**Olive Downs Coking Coal Project**  
Draft Environmental Impact Statement

**Attachment 4**  
**Peer Review Letters**

**Pembroke Olive Downs Pty Ltd**  
**Olive Downs Coking Coal Project**  
**Final Peer Review of HS**  
**Groundwater Assessment and Modelling**

**Dr F. Kalf**  
**B.Sc. M.App.Sc PhD**  
**27 July 2018**

**Figure A. (From HS Figure 4-6) Section indicating dipping Leichardt and Vermont coal seams and outlined open pit extent to a final depth of about 0mAHD.**

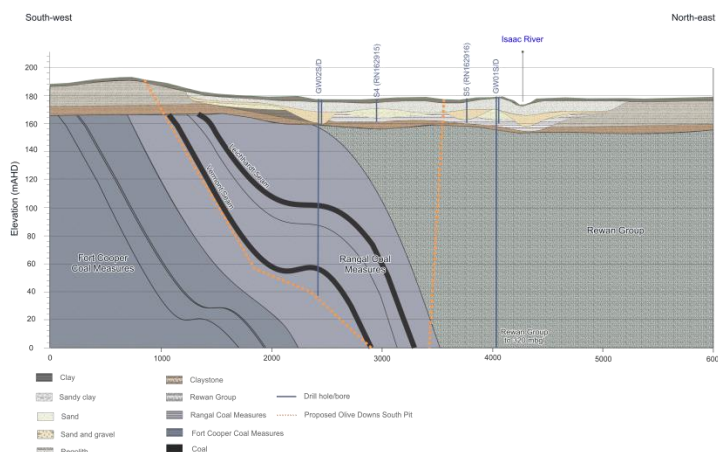
Conceptualisation for the HS model is considered suitable as shown in the sections of the syncline geological structure (Figure 5-34 and 5-35) (HS 2018).
